Leahy Park Fieldhouse Renovation

Bid # 26-21

ADDENDUM No. 2

March 31, 2026

NEW WORK

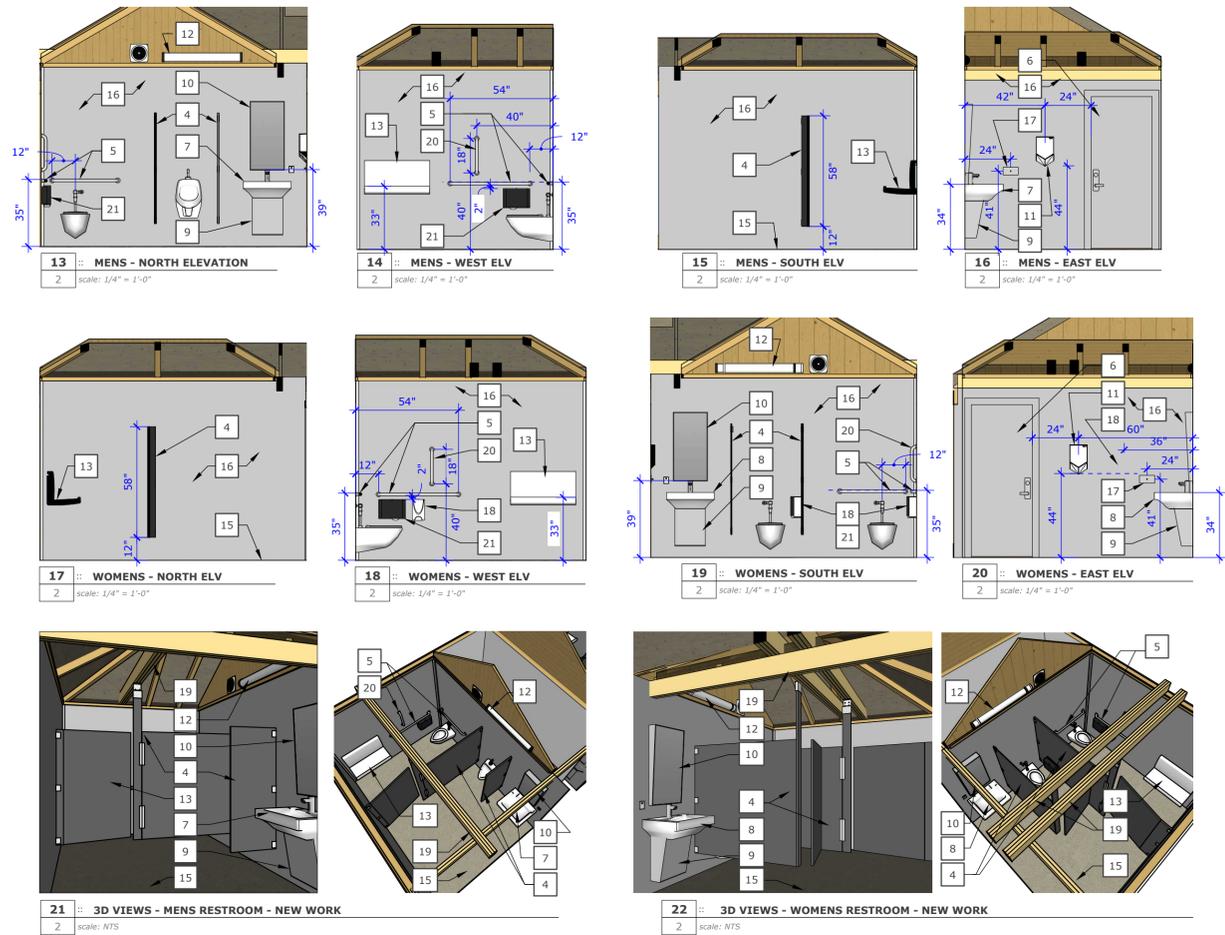
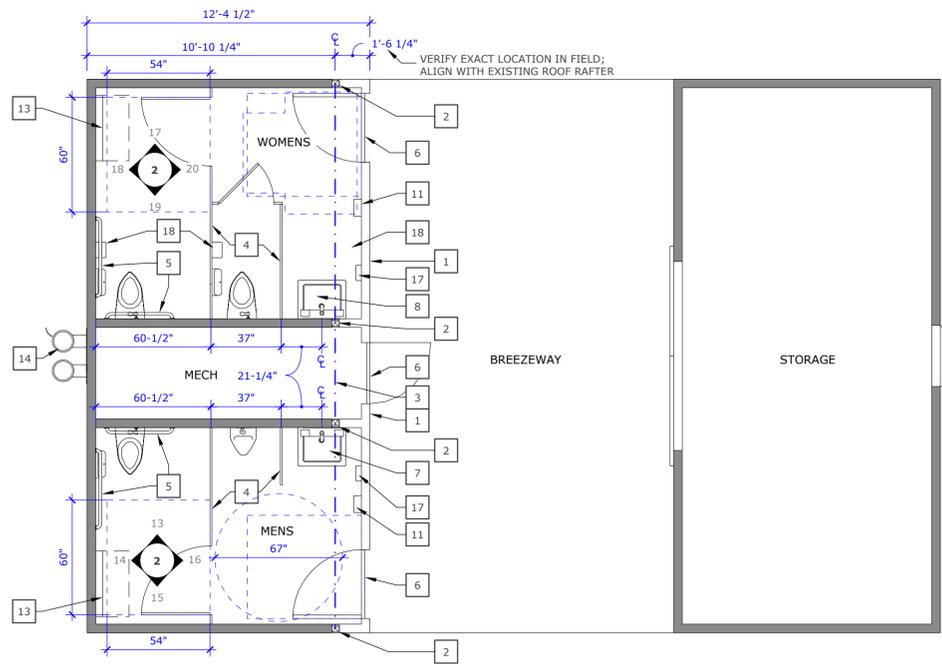
- NEW WALL-MOUNT DRINKING FOUNTAIN, PER SPEC. SHALL BE MOUNTED SO THAT SPOUT IS LESS THAN 36" ABOVE THE GROUND.
- ~~NEW POLISHED CONCRETE TOPPING; FLOORS OF MENS AND WOMENS RESTROOMS.~~

SEE ADDENDUM 2 FOR RESTROOM FLOORS

The previously specified “polished concrete topping” is hereby deleted. In lieu thereof, provide mechanically polished finish of the existing concrete slab.

In lieu of the polished concrete finish (Section 1a), provide a urethane concrete topping system with integral precast cove base at all restroom perimeter walls.
